## SCHEDULE A: Applications with Recommendation

**Appn Ref No:**  
19/0184

**Location:** Land Adjacent to Hillcrest, Milton, Brampton, CA8 1HS

**Proposal:** Erection Of 1no. Dwelling

BLOCK PLAN

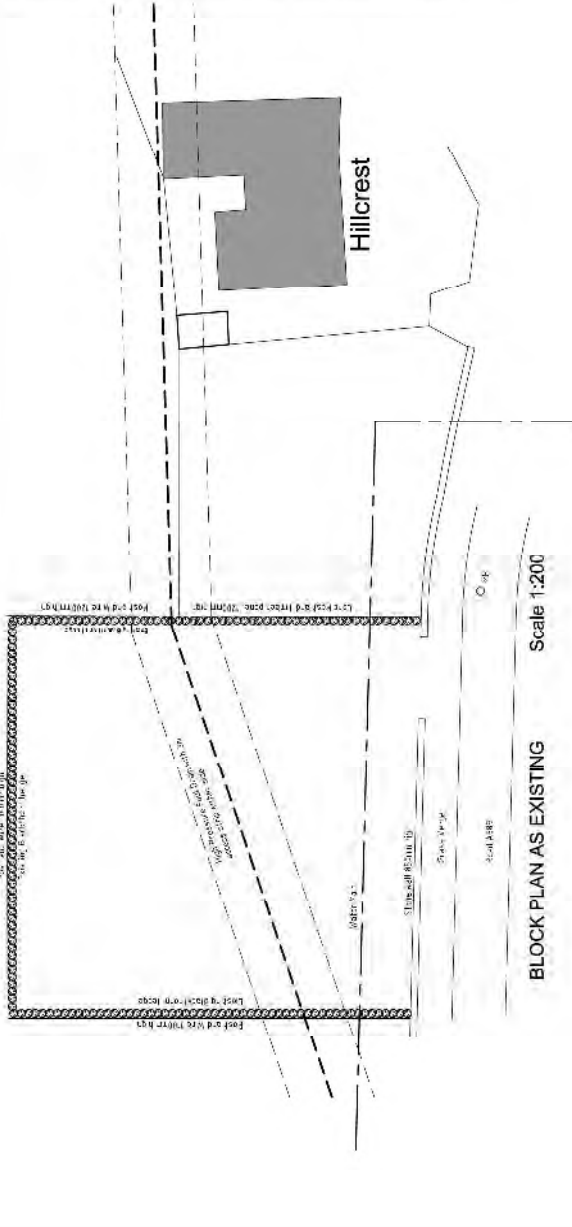
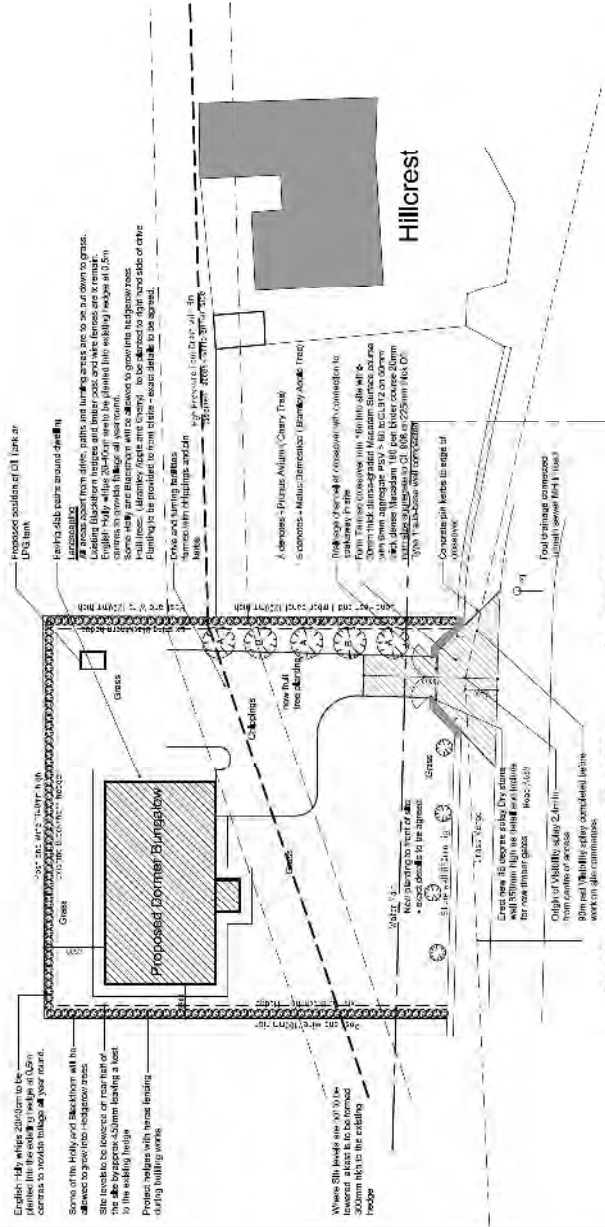
- when the outline plans were originally submitted we argued that the maps drawn by UU were outdated and incorrect. This has since been proven to be the case. The sewer pipe is indeed a lot further back than in the diagram used in the outline plans and on Mr Ridley's plans meaning the proposed house still has one corner that lies on the easement access strip/the pipe;

- unclear about the exact location of the pipe and the angle it goes through Mr. Ridley's plot, we also believe the proposed soakaway and the tree may lie on top of it;

- other concern is the drive being built over the UU "trunk main" UU have informed me that this pipe is a 15" pipe that cannot be dug near or over. When widening our drive we were not permitted within 3 metres of the pipe because we would flood Milton if it were to be disturbed/broken;

**Brampton Parish Council:** - objects to the application. Members were initially concerned with the outline planning application at this site with regards to the issues raised by United Utilities. An added concern is that the soil pipe is apparently not correctly drawn on the plans and the property would need to be pushed further back in order to cause no disturbance to the pipe. If the property footprint is relocated, it further detaches itself from the village of Milton which is contrary to Policy HO6 in that its location is inappropriate.

- 6.18 United Utilities has also noted that a public rising main runs through the site and it will require an access strip width of 6m, 3m either side of the centre line of the sewer. Deep rooted shrubs and trees should not be planted in the vicinity of the public sewer. In addition, a 15 inch critical water trunk main crosses the site. United Utilities needs unrestricted access for operation and maintenance purposes and development is not permitted over, or in close

12. The development shall not commence until visibility splays providing clear visibility as Drawing Number 2019/2/2/002 Rev D (received 9th December 2019). Notwithstanding the provisions of the Town and Country Planning (General Permitted Development) (England) Order 2015 (or any Order revoking and re-enacting that Order) relating to permitted development, no structure, vehicle or object of any kind shall be erected, parked or placed and no trees, bushes or other plants shall be planted or be permitted to grown within the visibility splay which obstruct the visibility splays. The visibility splays shall be constructed before general development of the site
